**SANTA CLARITA VALLEY WATER AGENCY
NOTICE TO PLANHOLDERS**

ADDENDUM NO. 1

Project: T7, U4, U6 Wells PFAS Treatment, Saugus 1 and Saugus 2 Wells VOC Treatment and New Disinfection Facility Project

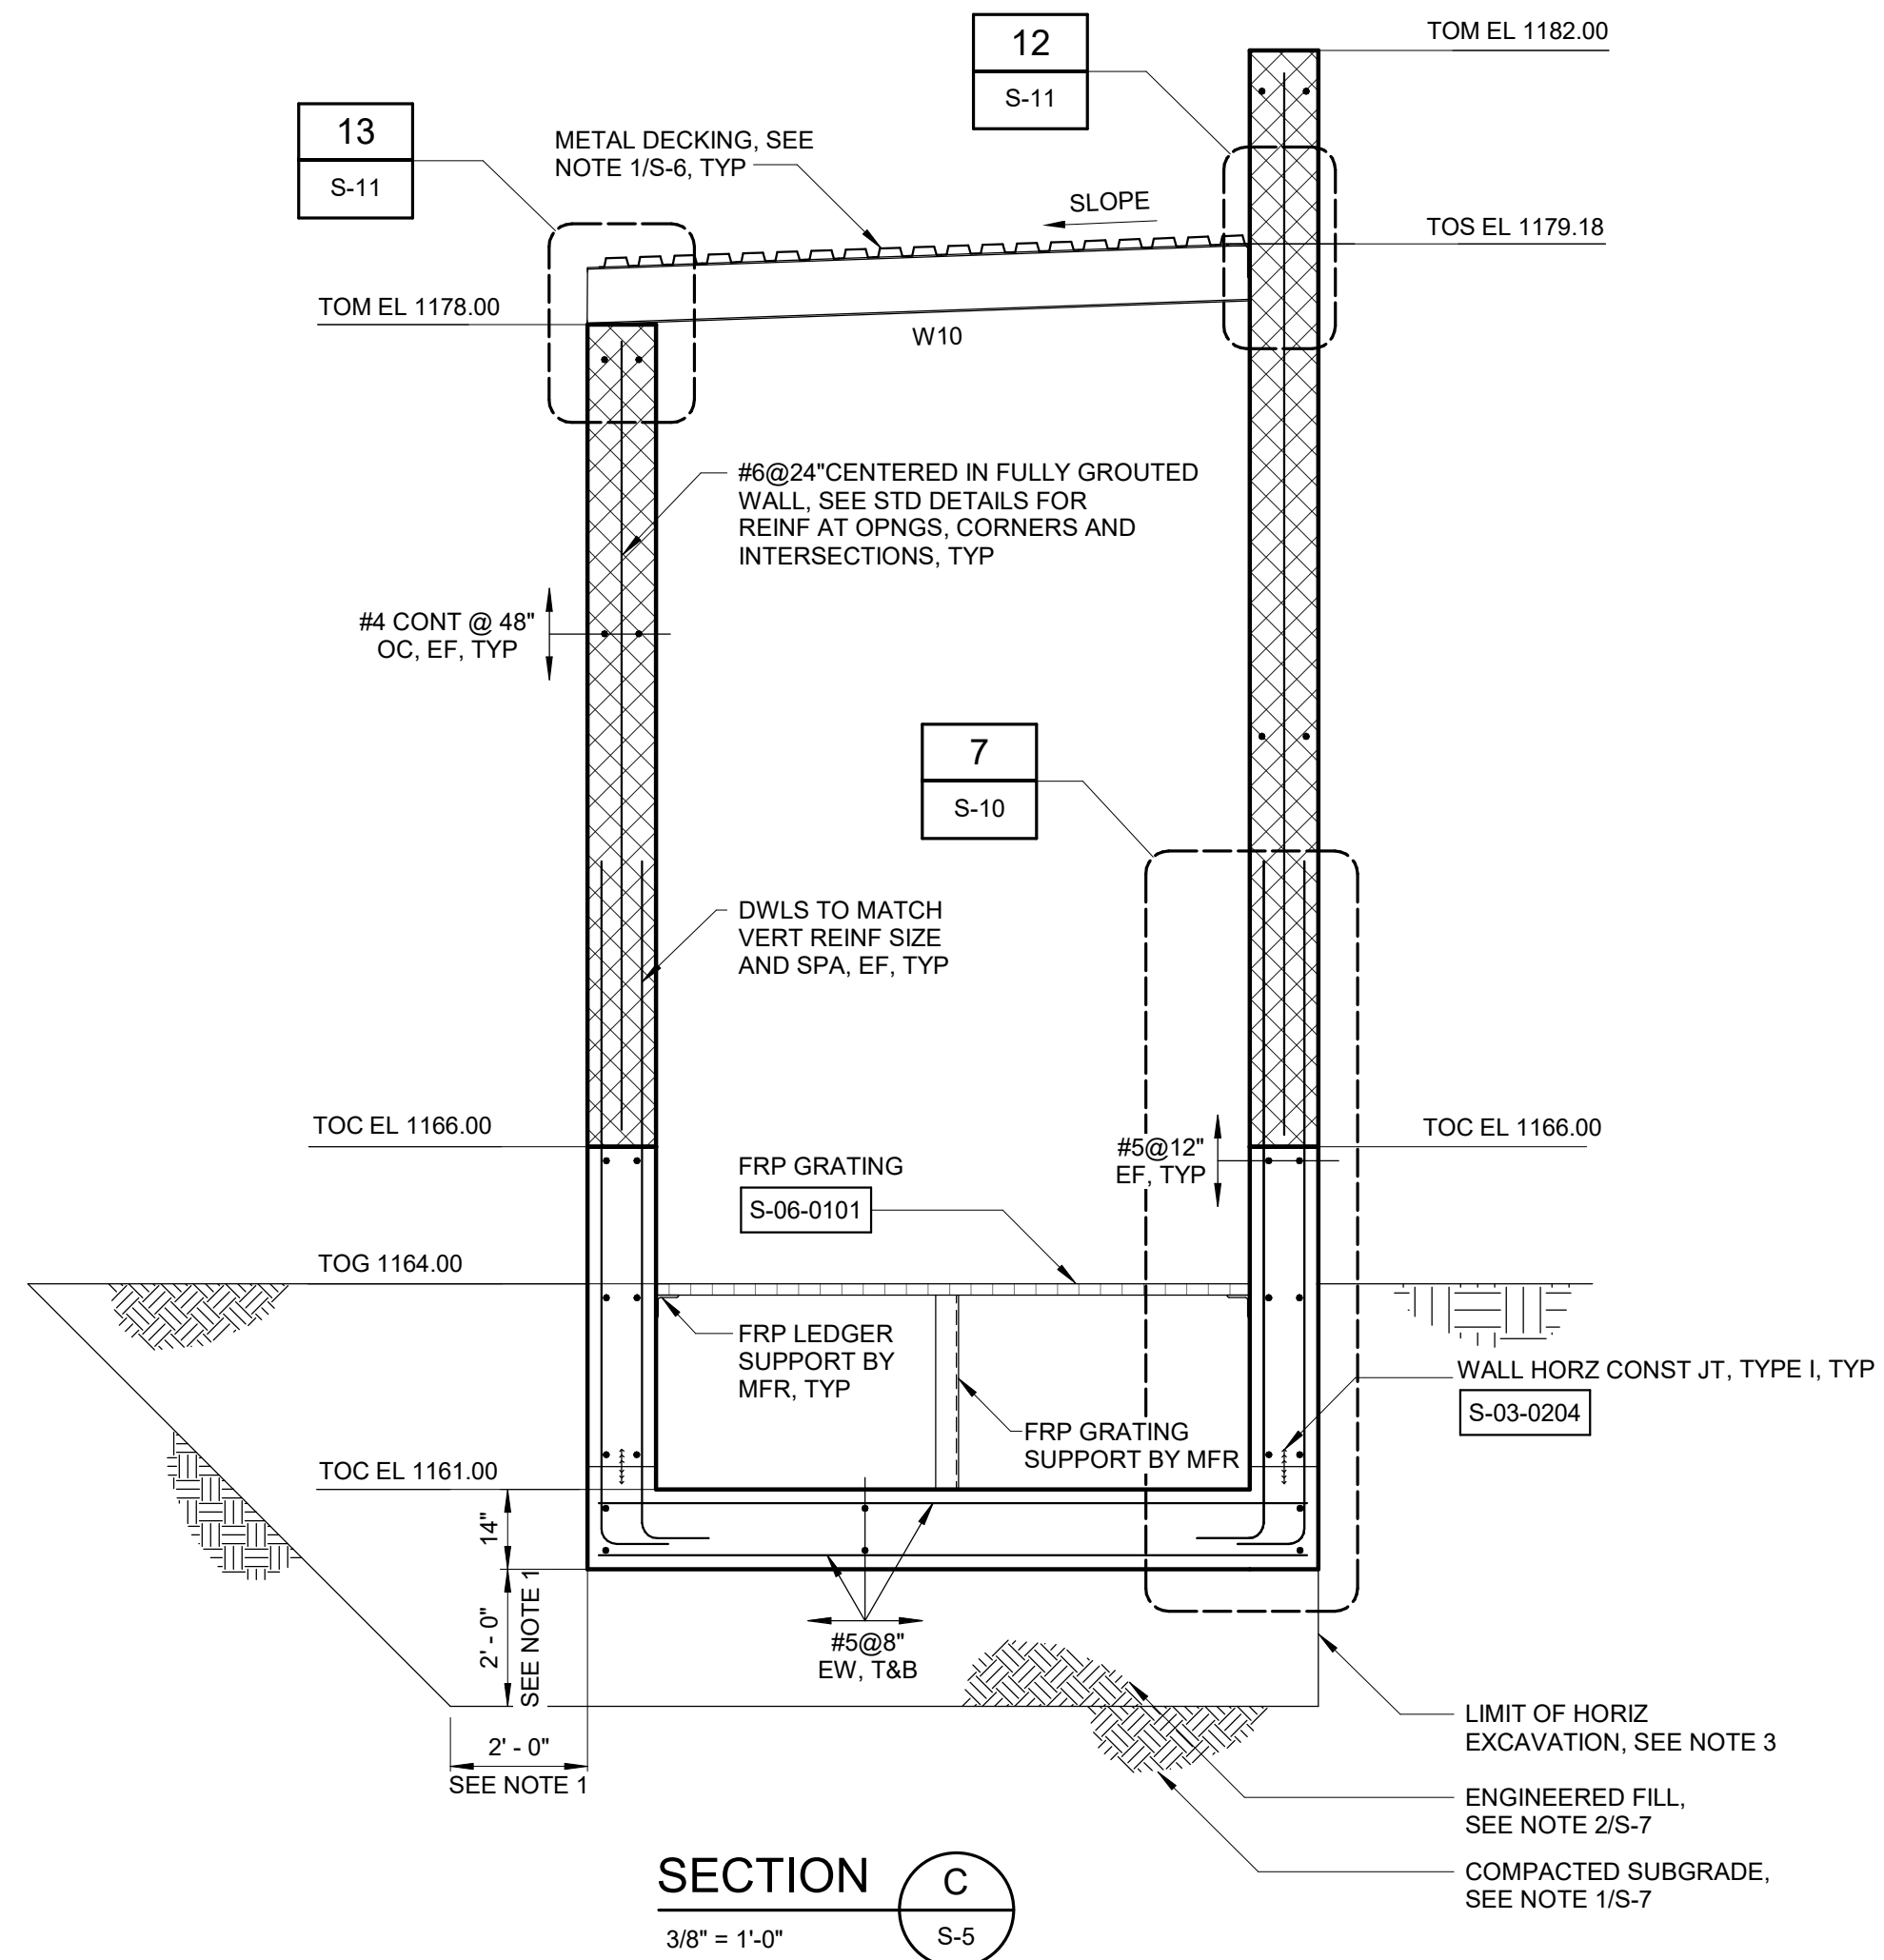
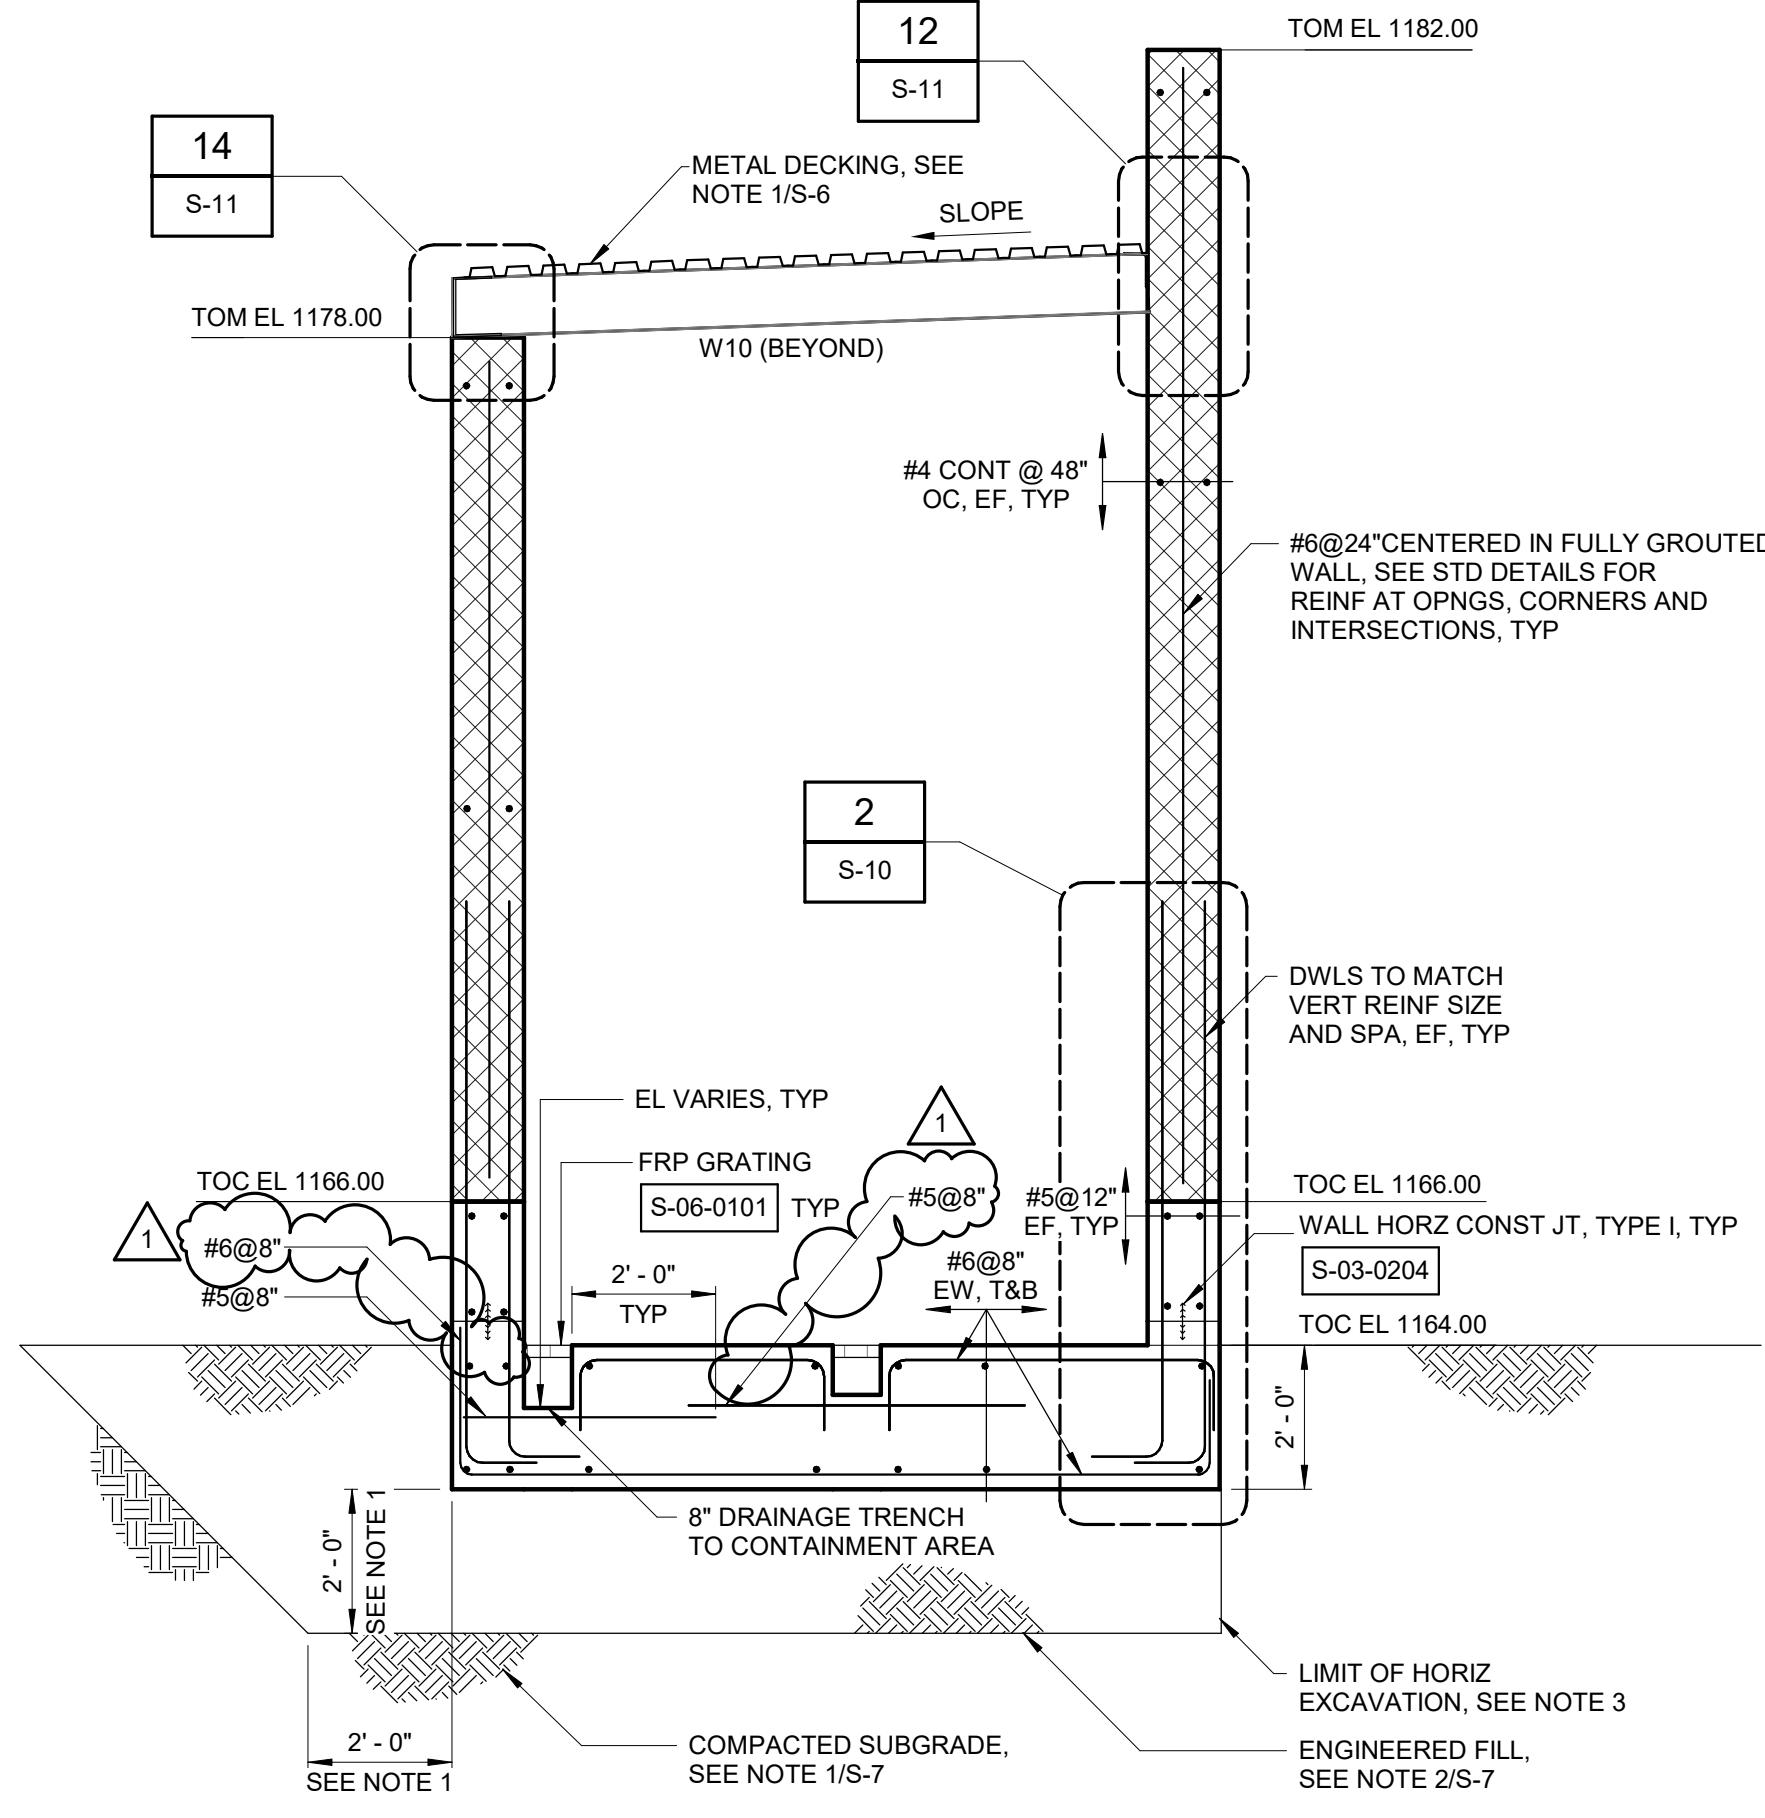
REPLACE Drawings M-10, S-1, S-4, S-5, S-6, S-9, S-11, A-1, A-5, A-6, and A-7 with the REVISED drawings attached.
